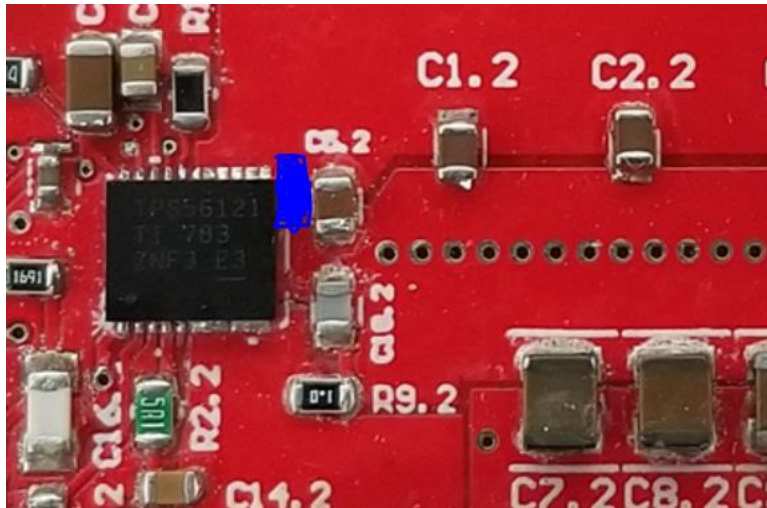
Place a 1uF ceramic where the blue mark is.

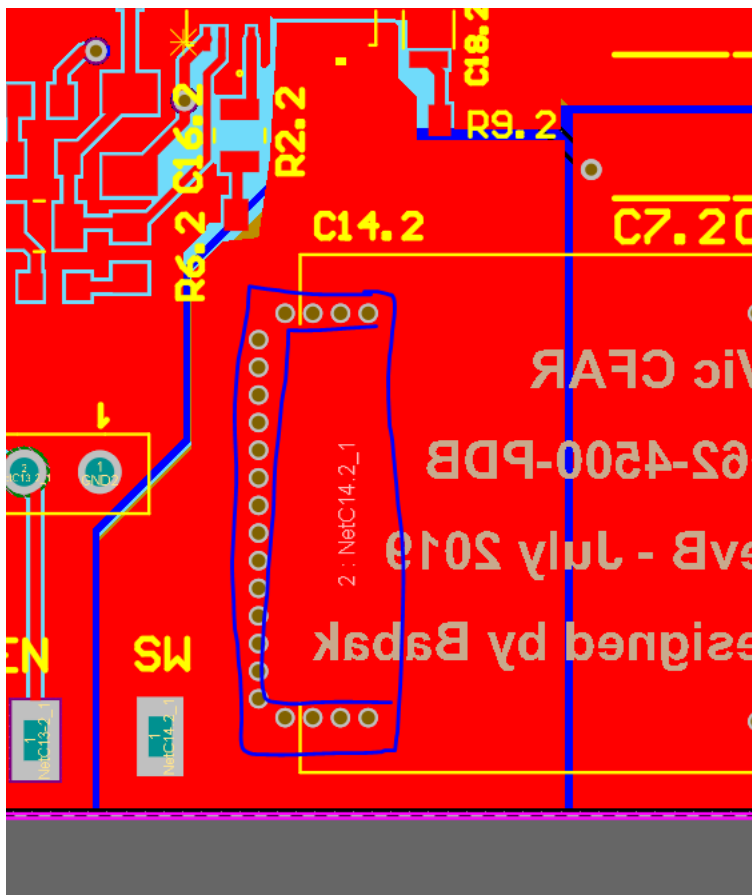
The SW node needs to be smaller.

There are vias connecting the SW node to two internal layers.

Cut the board so that the vias are not connecting to the internal nodes.

The clearance from the SW pour to other traces are as little as 3mils.

The clearance distance could be cause of the noise issue.

On the output. you are using 5x 100uF/16V capacitors.
The excel sheet is assuming 5x100uF. But the effective capacitance of a 16V caps used at 8V dc 50%.
Ceramics need to be derated based on the voltage.
Either double the capacitance to troubleshoot or recalc and change components.

PGOOD is connected incorrectly .
